6 IN THE SUPERIOR COURT OF THE STATE OF ARIZONA
7 IN AND FOR THE COUNTY OF MARICOPA

12 **OBJECTION TO SUBFLOW ZONE**
13 **DELINEATION REPORT FOR THE**
14 **SAN PEDRO RIVER WATERSHED**
15 **DATED JUNE 30, 2009**

Report of Jeanmarie A. Haney

Figure 1. From ADWR 2009 subflow report. Red crosshatched box is added and shows zone where tributary alluvium occurs as a thin layer over floodplain Holocene alluvium.

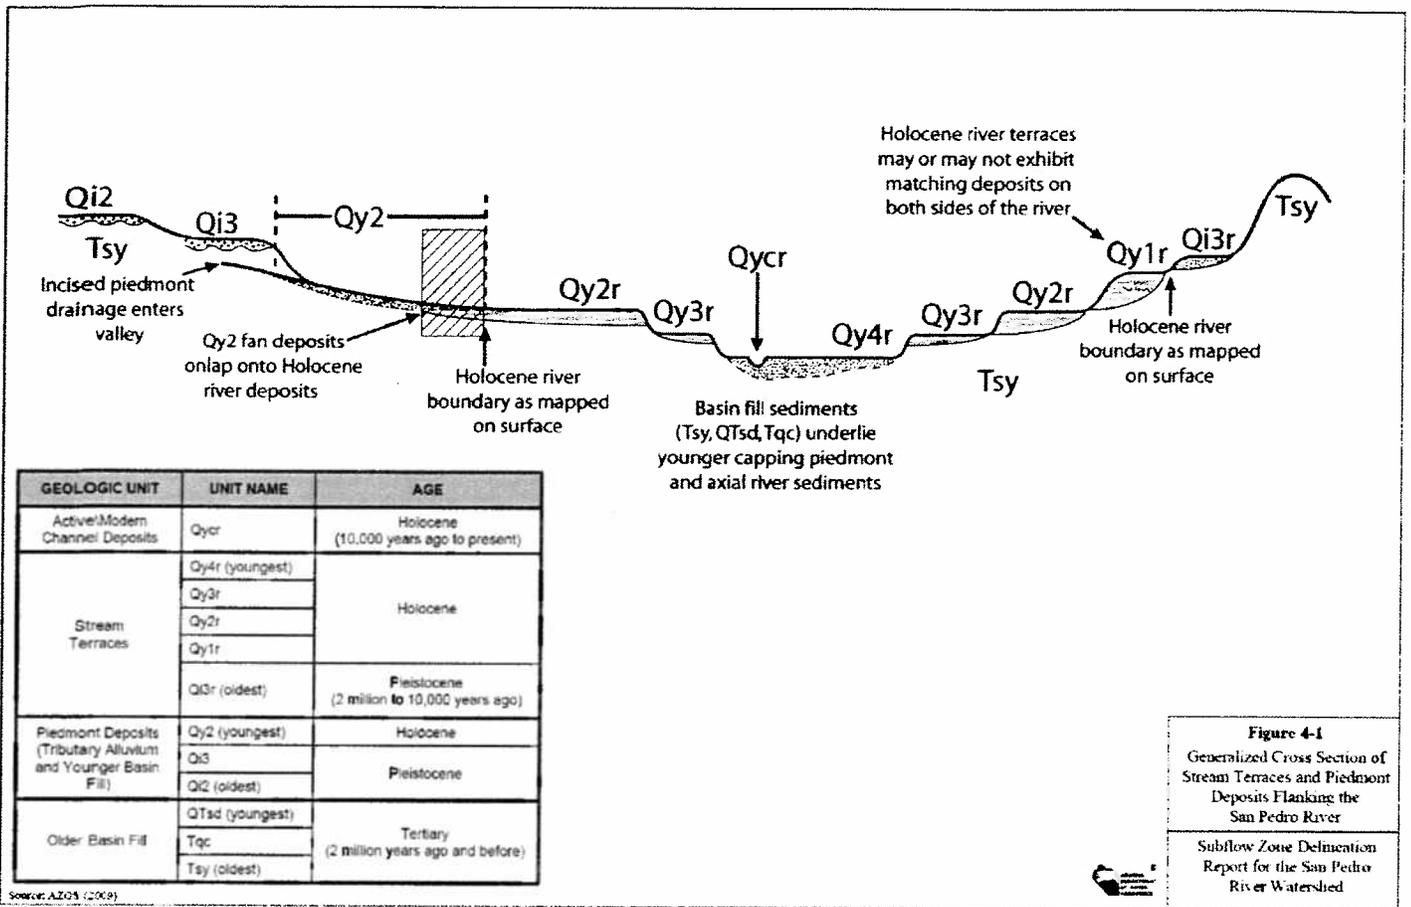
While acknowledging that tributaries have recently deposited alluvium on top of the floodplain (**Figure 1**), ADWR excludes all surficial exposures of tributary Holocene alluvium from the floodplain Holocene alluvium boundary, based upon their interpretation of Judge Goodfarb’s June 30, 1994 Subflow Order (“1994 Subflow Order”). ADWR asserts that subsurface mapping to delineate the extent to which tributary Holocene alluvium overlies floodplain Holocene alluvium would be impractical and beyond the scope of their report (ADWR 2009). While I agree that subsurface mapping is not practicable within the time frames of the adjudication proceedings, I believe some of the techniques discussed below can provide a reasonably simple means to delineate the subflow zone to more accurately correspond to the saturated floodplain Holocene alluvium. It is clear that ADWR’s delineation excluding all surficial exposures of tributary Holocene alluvium from the subflow zone does not meet the criteria for correlation to the stable geologic unit as set forth in the 1994 and 2005 Subflow Orders. The word “stable” occurs numerous times in these orders, originating with Judge Goodfarb’s 1994 Order, ...the floodplain Holocene alluvium “is the only stable geologic unit which is beneath and adjacent to most rivers and streams...” (Goodfarb 1994, p.56). The subflow zone as delineated by ADWR does not correspond to the stable geologic unit for two primary reasons: active channel migration will cause the river to leave the subflow zone and tributary deposits are transitional and easily eroded by active channel migration and high flows.

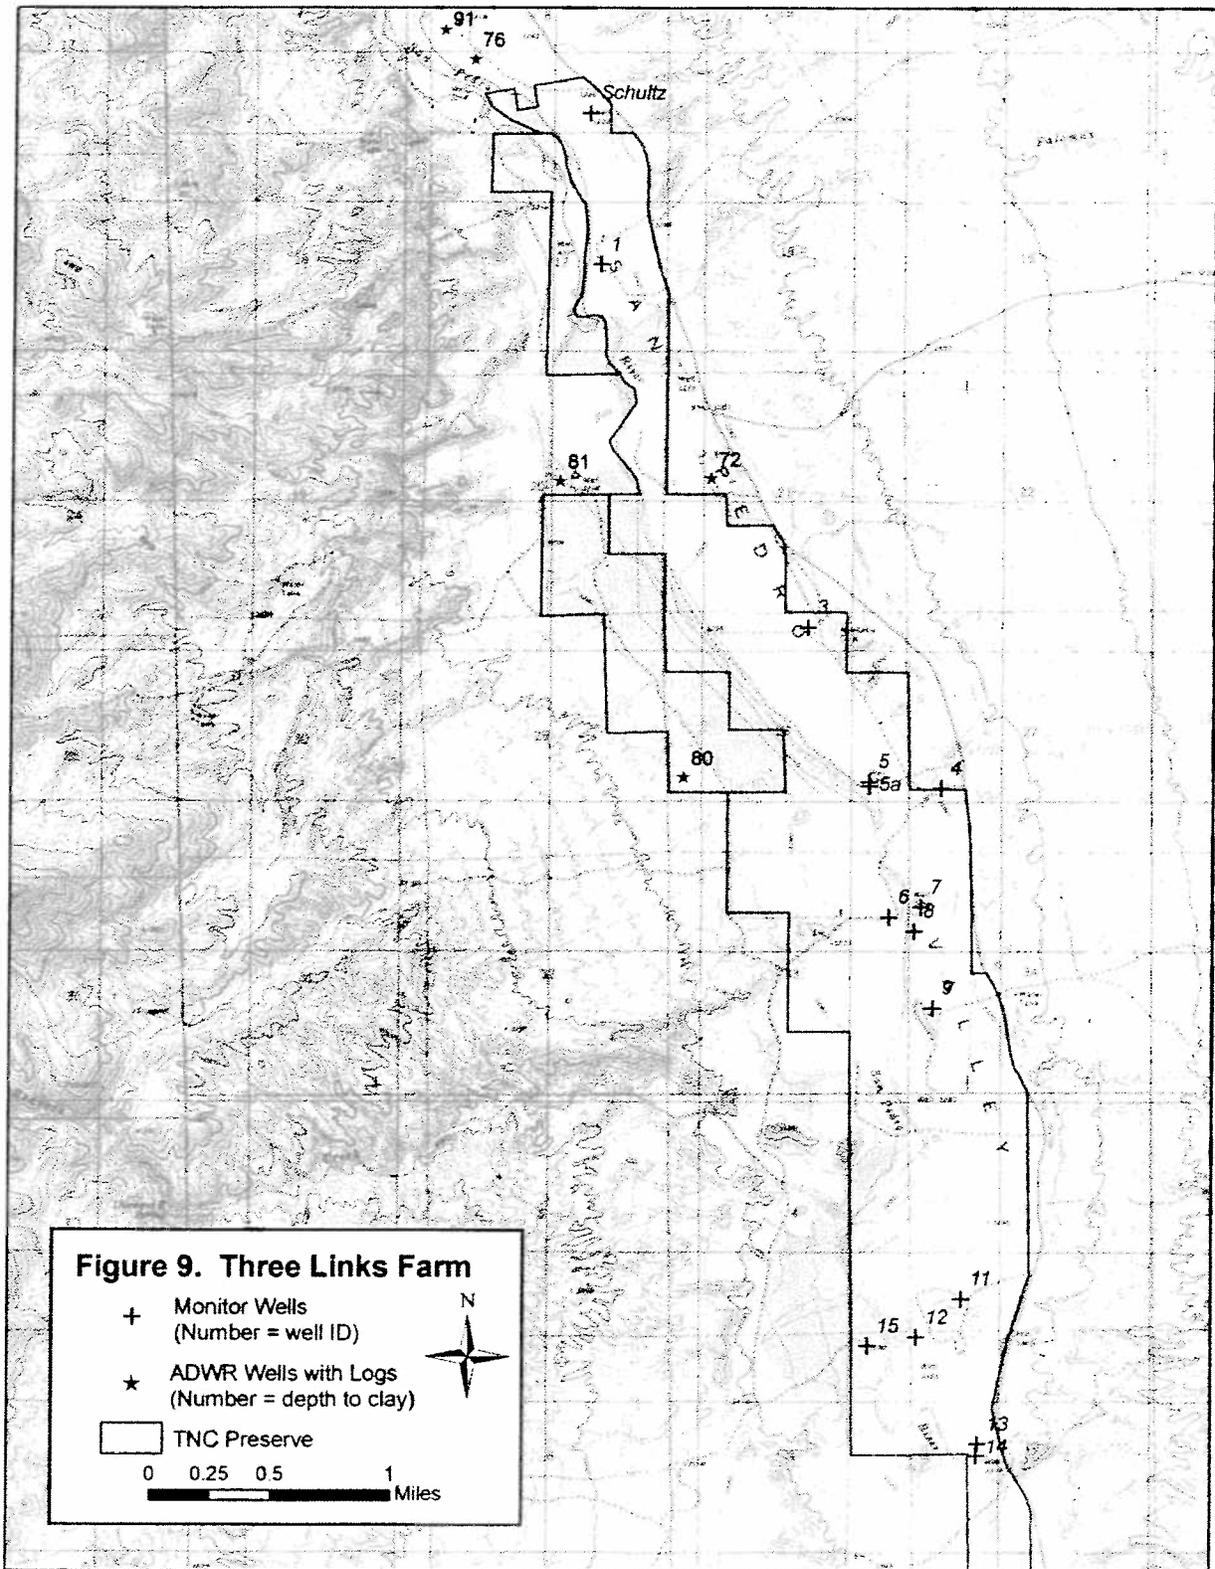
Using the cited data and references, I prepared **Figure 8**, which shows my interpretation of the subflow zone at H&E Farm (Haney Subflow Zone). Geologic logs, AZGS geologic mapping units, NRCS soil units, topography, and hydrogeologic data obtained during investigations and regular monitoring at the H&E Farm are the chief criteria on which I delineated the Haney Subflow Zone. Figure 8 also shows the ADWR Subflow Zone, which includes setbacks for “side recharge” and which does not include areas overlain by deposits of tributary Holocene alluvium.

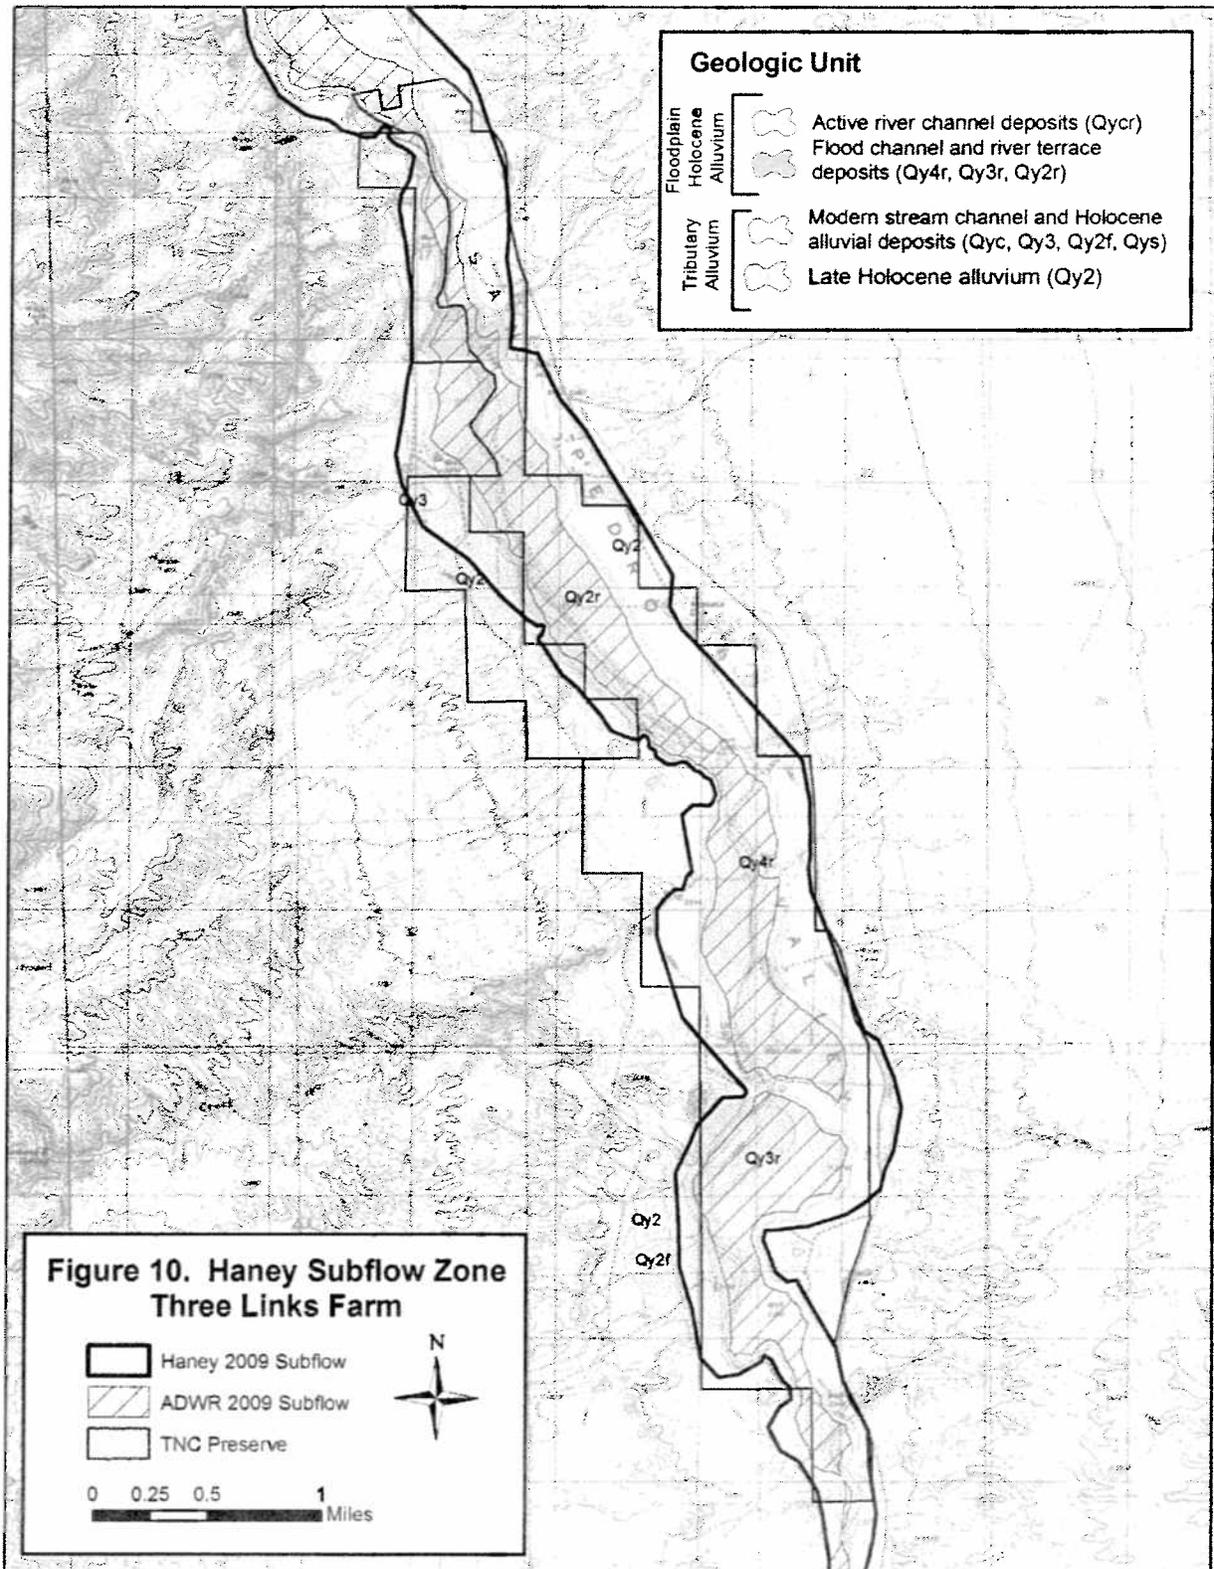
Using the cited data and references, I prepared **Figure 10**, which shows my interpretation of the subflow zone on Three Links Farm (Haney Subflow Zone). Geologic logs, AZGS geologic mapping units, NRCS soil units, topography, and

hydrogeologic data obtained during investigations and regular monitoring at the San Pedro River Preserve are the chief criteria on which I delineated the Haney Subflow Zone. Figure 10 also shows the ADWR Subflow Zone, which includes setbacks for "side recharge" and which does not include areas overlain by deposits of tributary Holocene alluvium.

Figure 11. Examples: ADWR Subflow Zone Excludes Active Channel

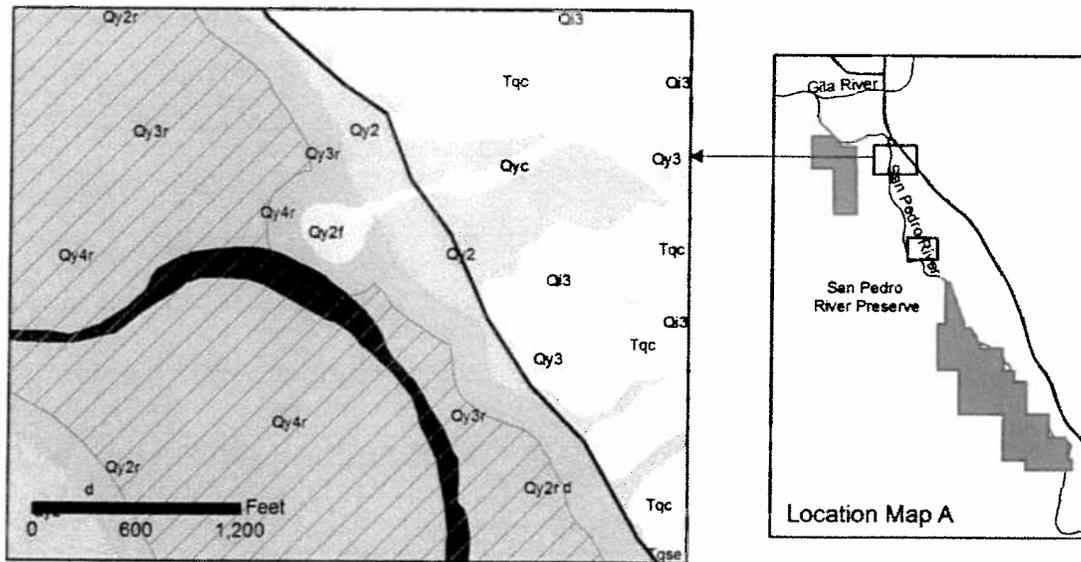
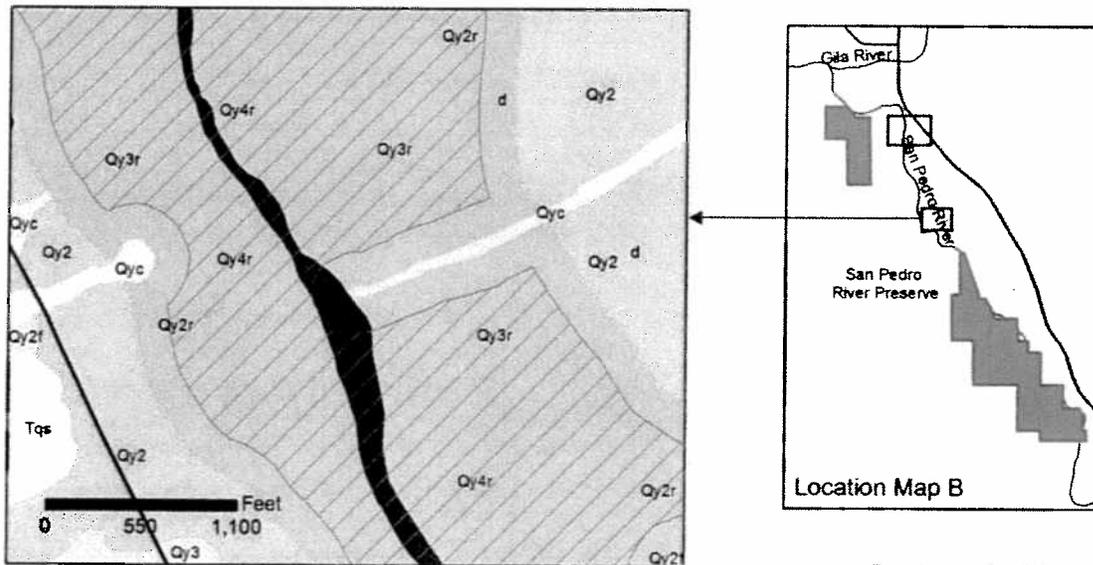
A. ADWR subflow zone excludes tributary alluvial fan (Qy2f). Portion of active channel outside subflow zone. Migration of active channel to northeast, as fan debris is removed, will place more of the river outside ADWR subflow zone.

B. ADWR subflow zone excludes the full width of the active channel, because a small finger of tributary alluvium (Qyc) overlies the floodplain Holocene alluvium.

Figure 13. Using Geologic Outcrop Pattern to Map Subsurface Extent of Floodplain Holocene Alluvium

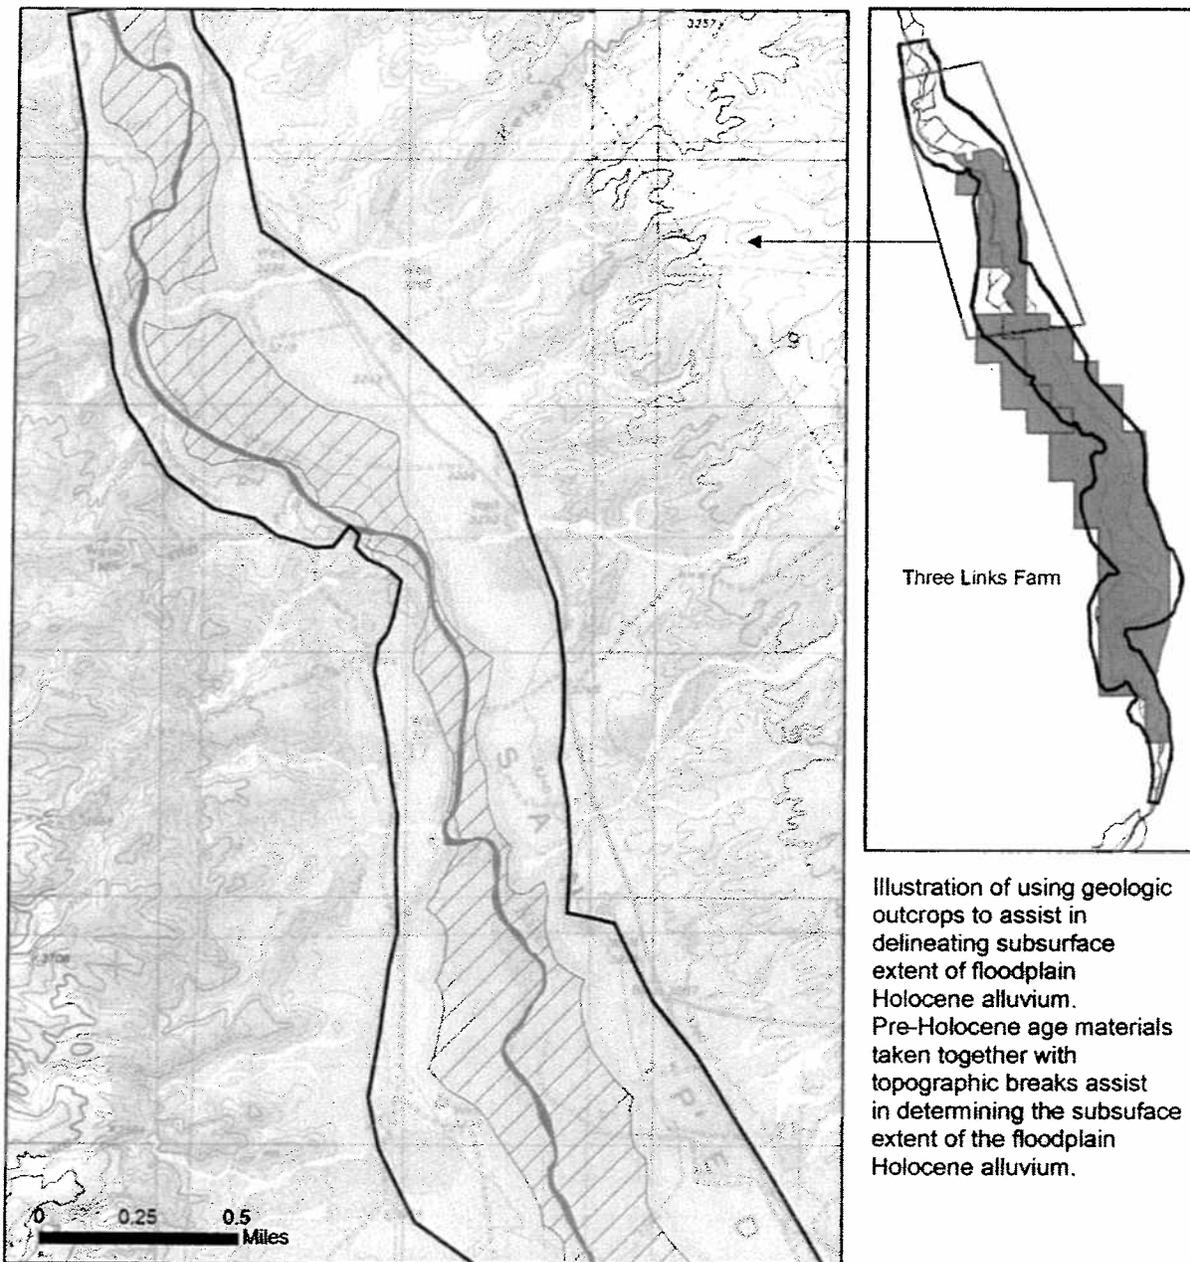
Illustration of using geologic outcrop patterns to assist in delineating subsurface extent of floodplain Holocene alluvium. Pre-Holocene age materials taken together with topographic breaks assist in determining the subsurface extent of the floodplain Holocene alluvium.
